PLANNING & ZONING CASE NO. SP2020-012

PHOTOMETRIC PLAN
SADDLE STAR ESTATES
SOUTH PHASE TWO A
LOT CA-4
~AMENITY CENTER~

I.1 This is a request for the approval of a Site Plan for the amenities center for the Saddle Star Estates Subdivision being a 0.782-acre portion of a larger two (2) acre tract of land identified as Tract 1 of the P. B. Harrison Survey, Abstract No. 97, City of Rockwall, Rockwall County, Texas, zoned Planned Development District 79 (PD-79) for Single-Family 8.4 (SF-8.4) District land uses, situated within the SH-205 By-Pass Overlay (SH-205 BY-OV) District, located on the north side of John King Boulevard south of Featherstone Drive.

LS1 of 2

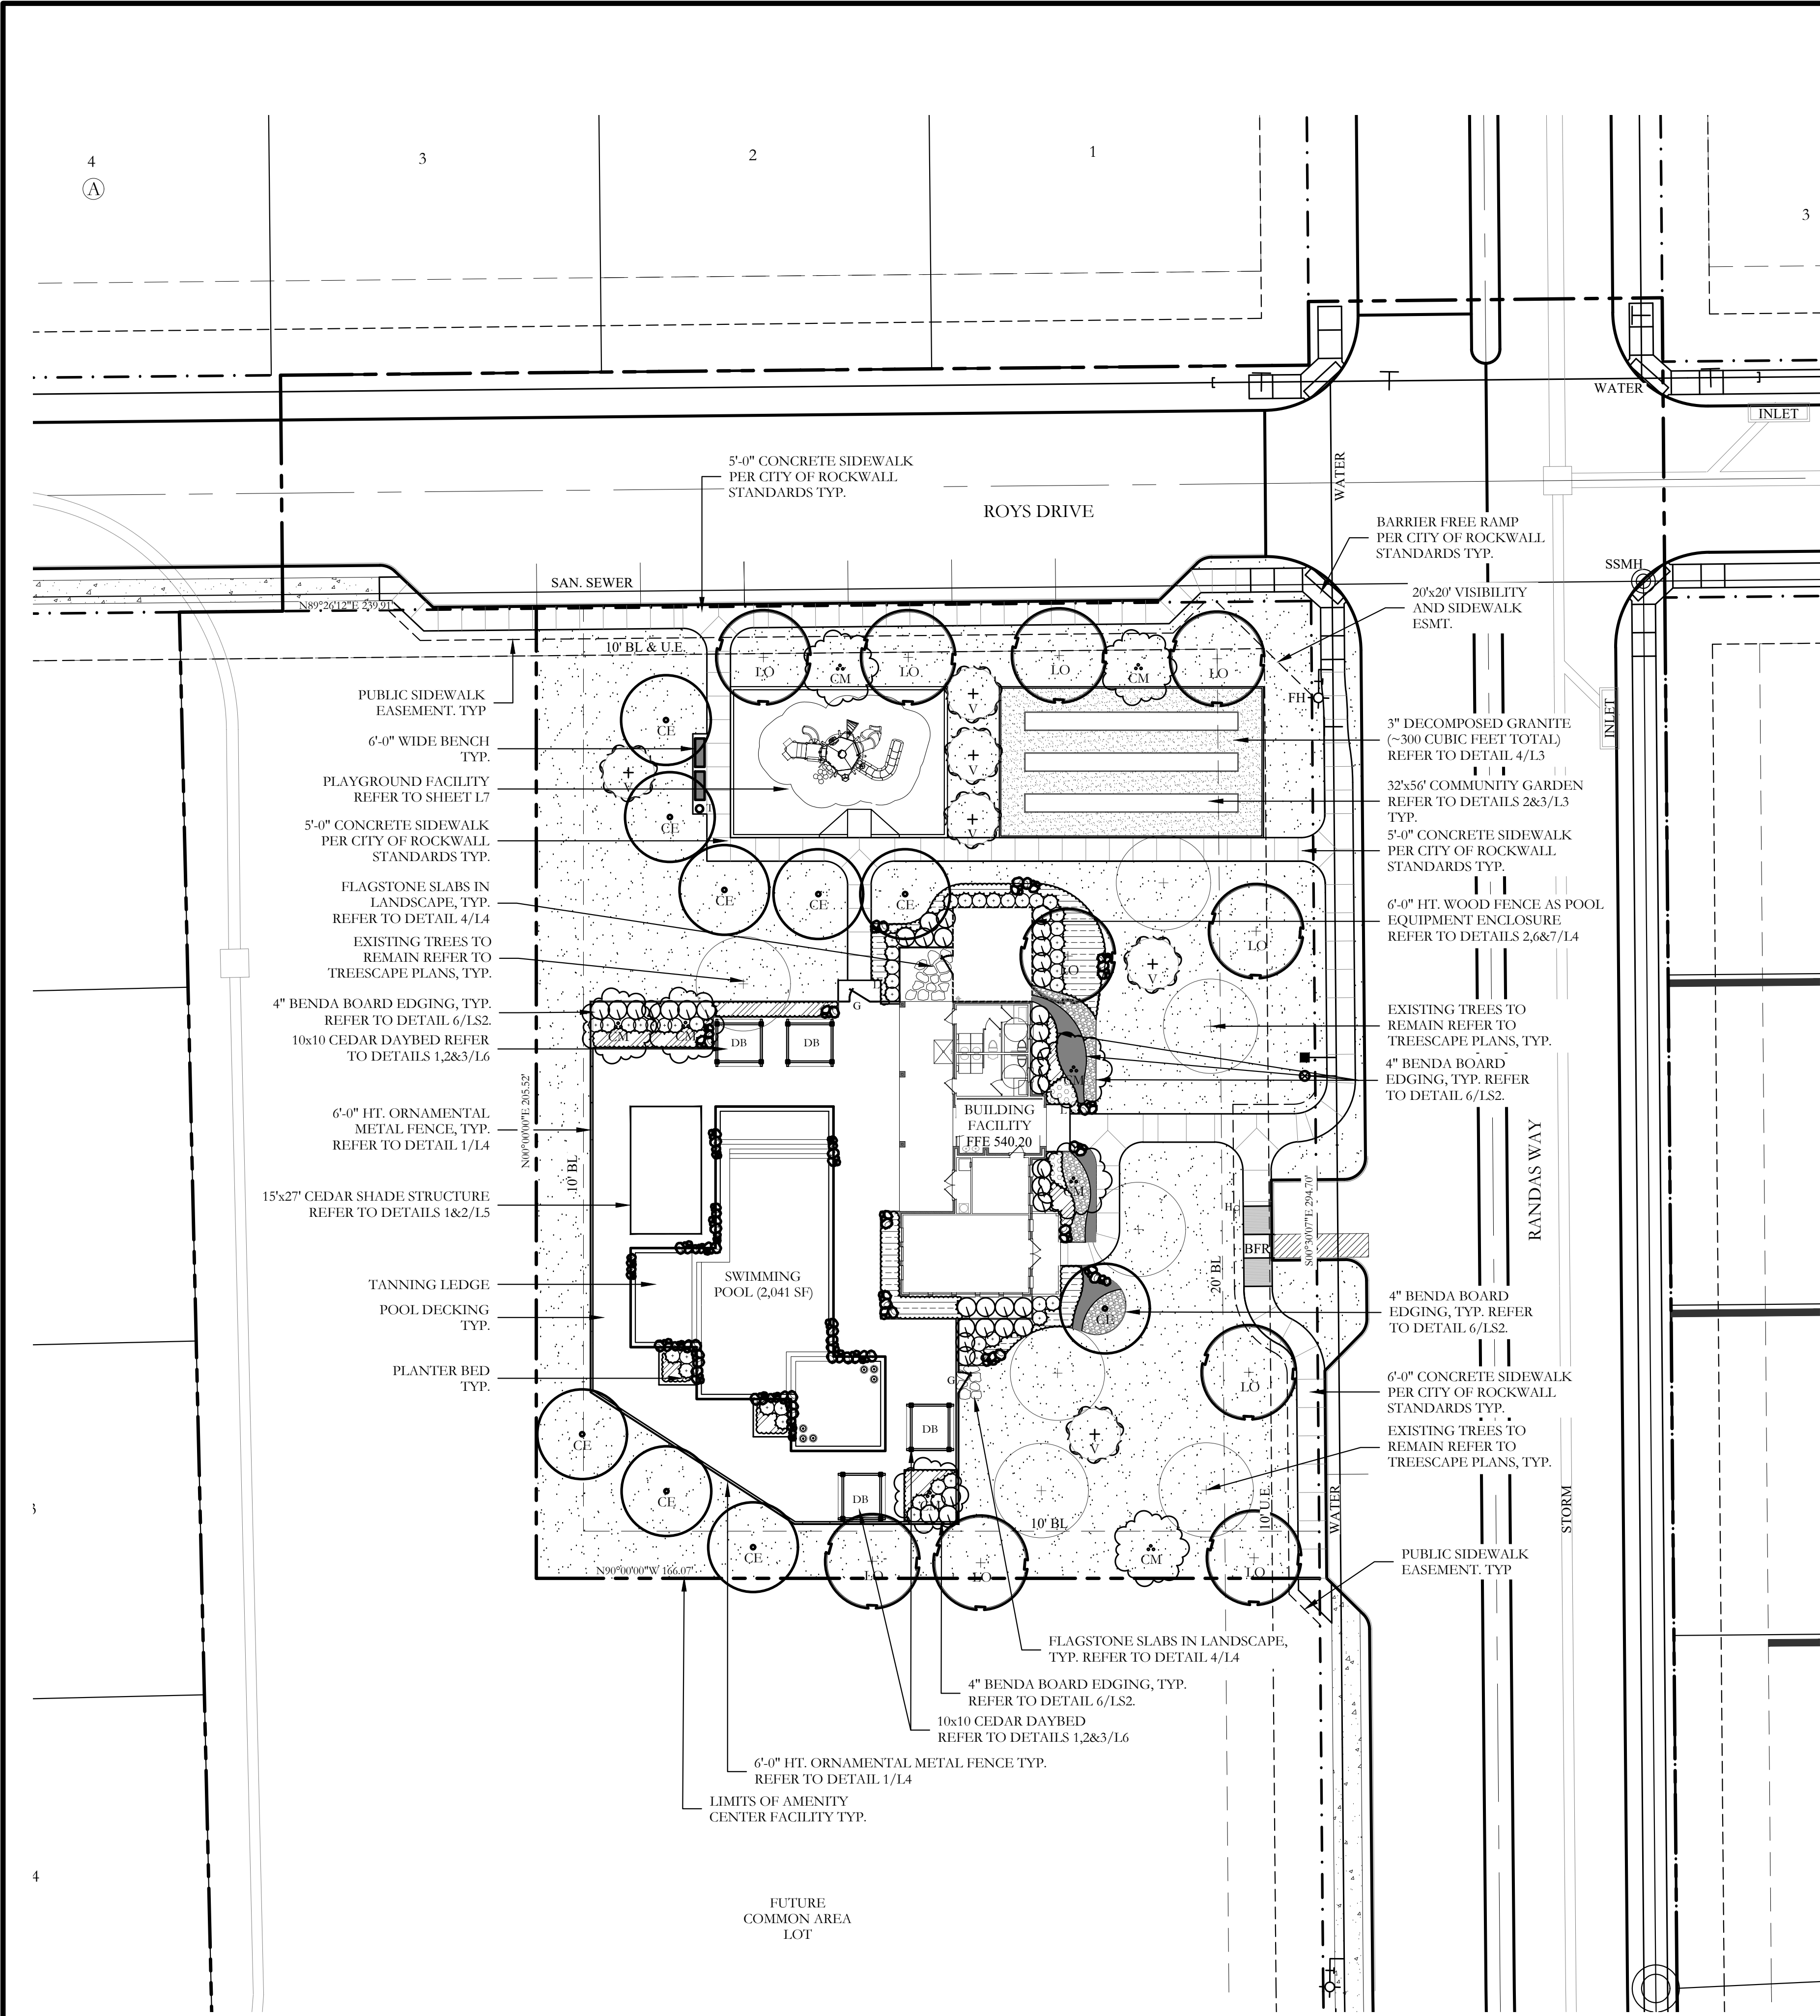
- 1) Correct the Landscape Plant Legend of sheet LS1 of 2 to indicate a minimum of 5-gallon size for the Sunshine Ligustrum shrubs. (§05.03.B, Art. 08, UDC)
- 2) Correct the Landscape Plant Legend of sheet LS2 of 2 to indicate a minimum 4-inch caliper for the required canopy trees (i.e. Live Oak & Cedar Elm) and a minimum of 5-gallon size for the Sunshine Ligustrum shrubs. (§05.03.B, Art. 08, UDC)
- 3) Provide a note for the decomposed granite -- located in the community garden -- that a plant bed edge will be used to prevent the materials from spilling outside of the garden area. (§01.02(D), Art. 11, UDC)
- 4) Provide note indicating that trees must be planted at least five (5) feet from water, sewer and storm sewer lines. (Subsection 5.03.E, Art. 08, UDC)
